**From:** Turchy, Michael A  
**Sent:** Monday, July 7, 2025 10:05 AM  
**To:** Annino, Amy; Jamison, John  
**Cc:** Amschler, Crystal C CIV USARMY CESAW (US); McHenry, David G; Wojski, Paul A; Pjetraj, Michael; Bukowy (HNTB), Kat A  
**Subject:** RE: Request for Additional Information: DWR 20250109 V3 - Hurricane Helene I-40 Pigeon River Gorge Emergency Relief Project

**Subject:** Request for Additional Information: DWR 20250109 V3 - Hurricane Helene I-40 Pigeon River Gorge Emergency Relief Project

# TIP PROJECT: I-40 PIGEON RIVER

**S-006R3: REVISED PERMIT DRAWINGS**  
**DATE: 06/03/2025**

### WETLAND AND SURFACE WATER IMPACTS SUMMARY

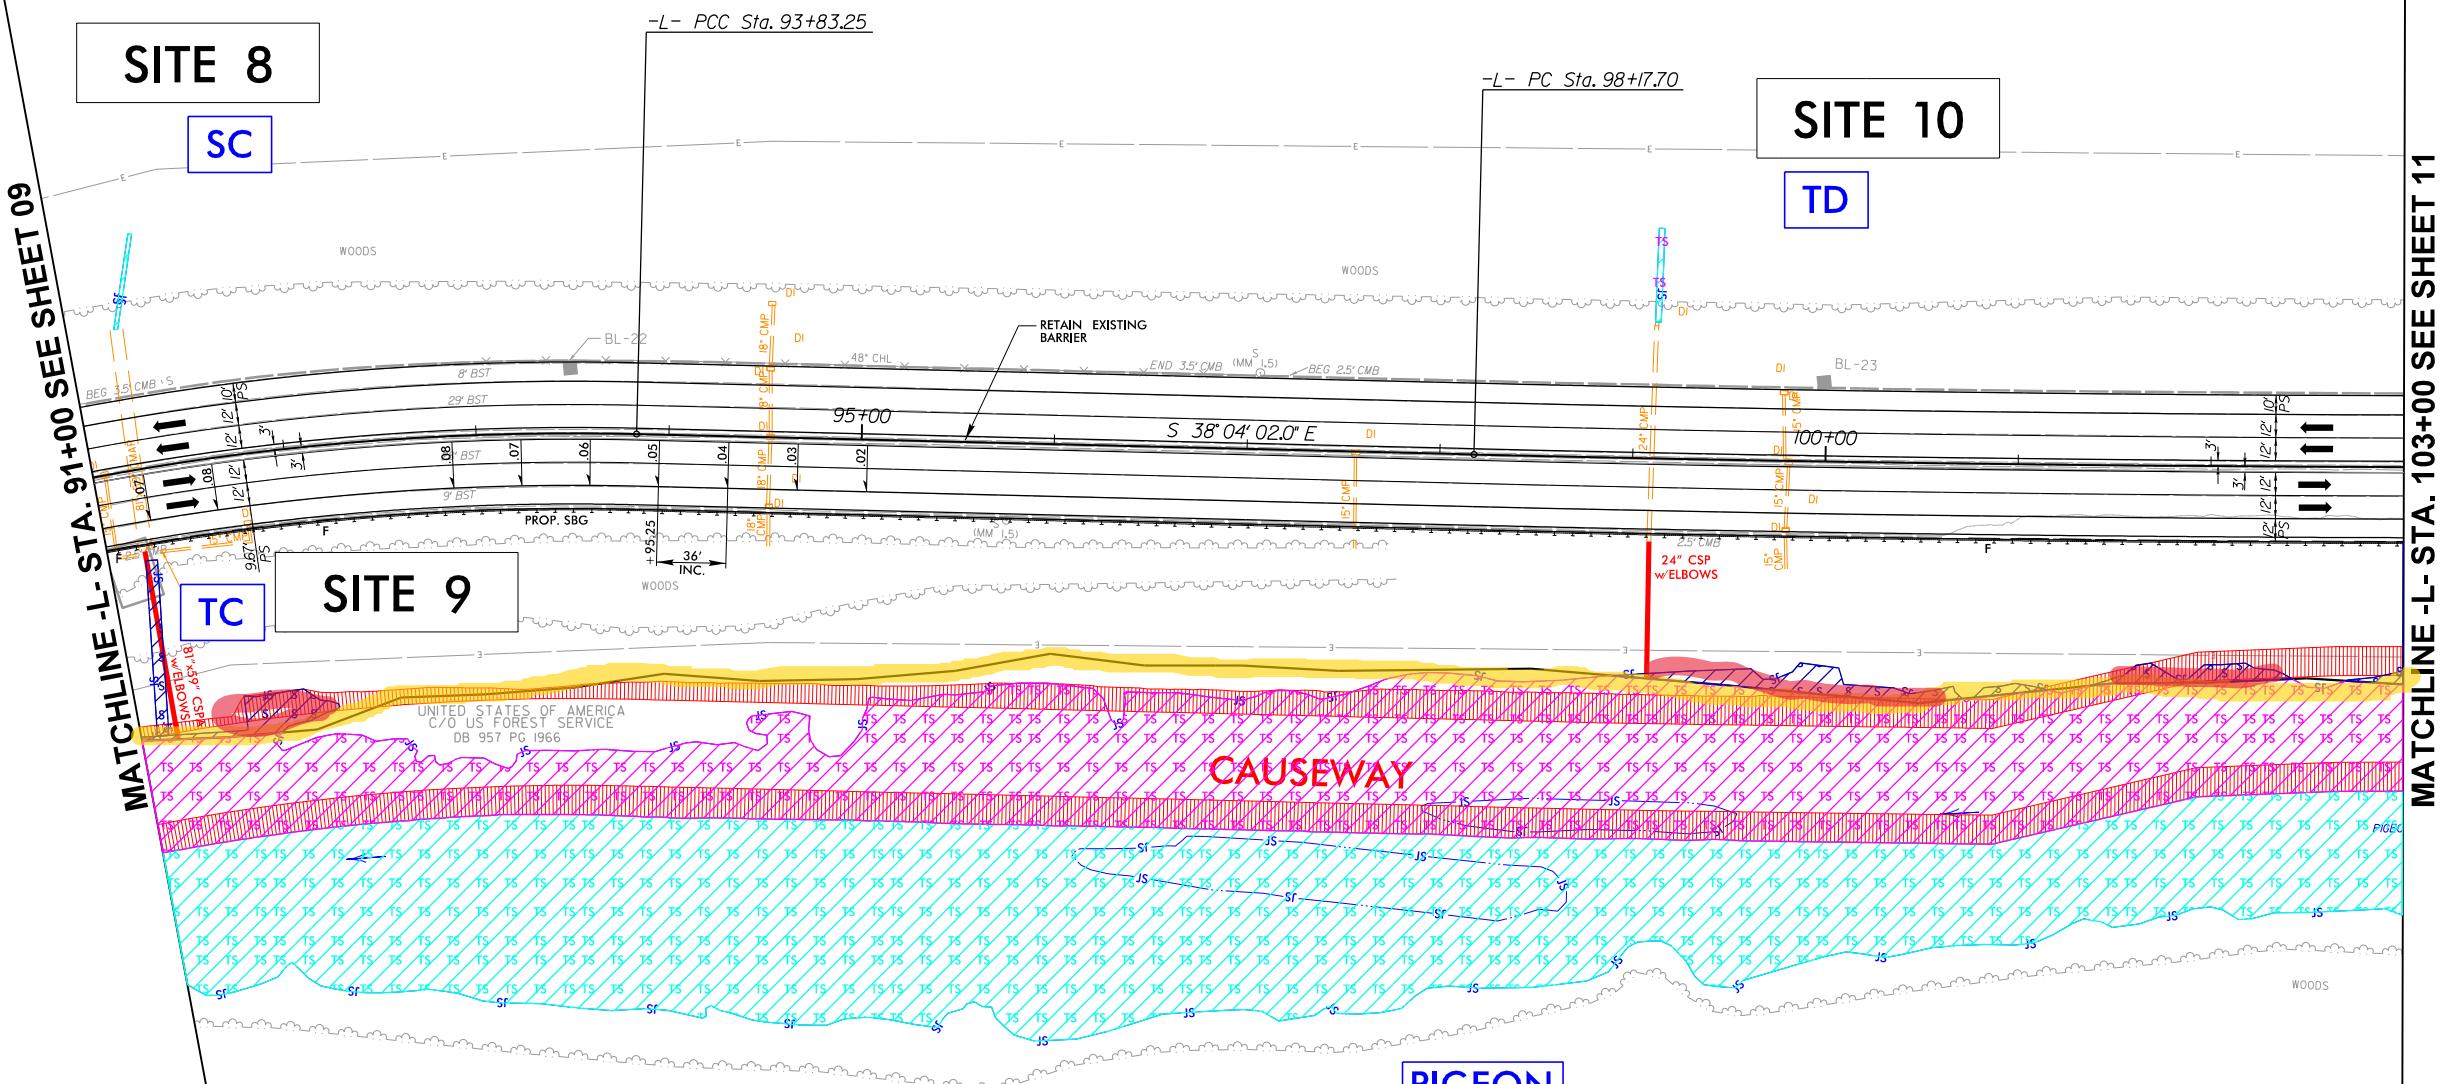
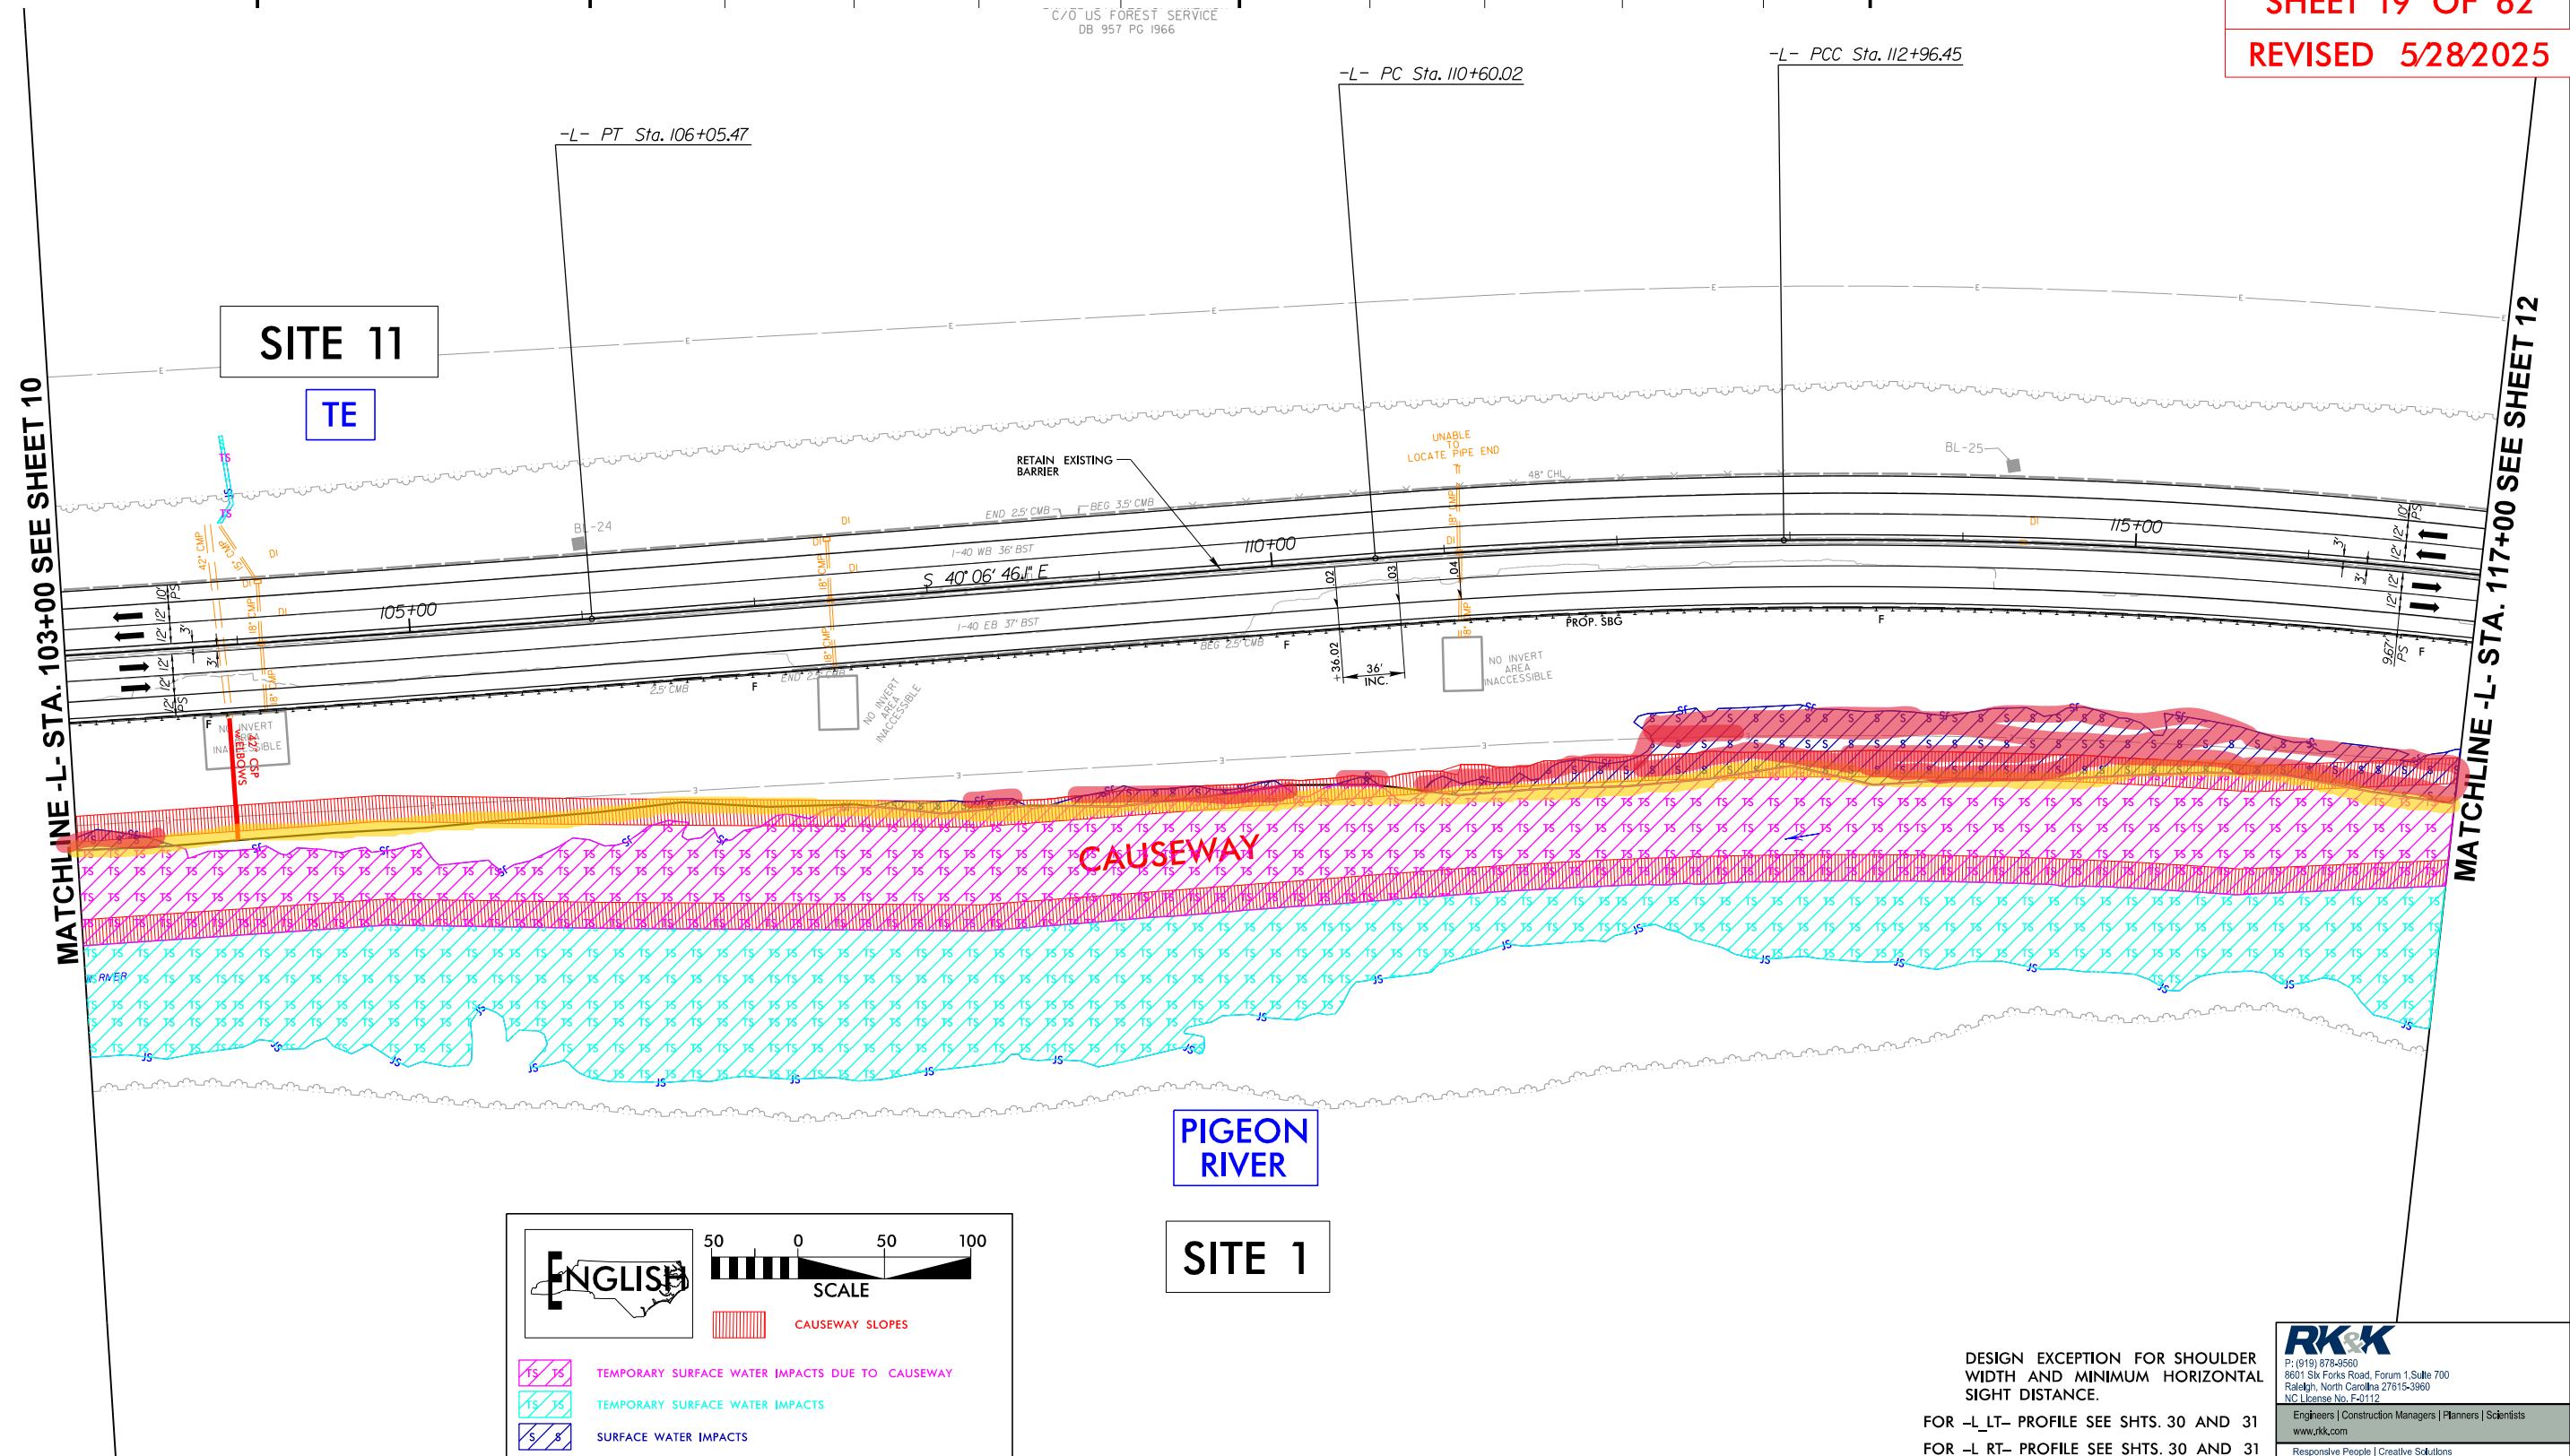
3. Please show the footprint of the proposed retaining wall through the project area

The proposed wall is located on the submitted set of drawings, and attached is a marked up set of drawings highlighting the wall for clarity, titled “**Drawings with Wall Highlighted**.”

The wall is highlighted in yellow. Wall impacts are highlighted in red.

Additionally, the impact summary table has been excerpted on each page to clarify the quantify the wall impact.

As previously noted, impacts are shown using the “scour zone limits” of the Pigeon River, as locating the ordinary high water mark post-Helene is not possible. Therefore, these drawings display a “worst case scenario” and are likely much lower than indicated.

The total proposed wall impacts to the Pigeon River are 12,116 linear feet.
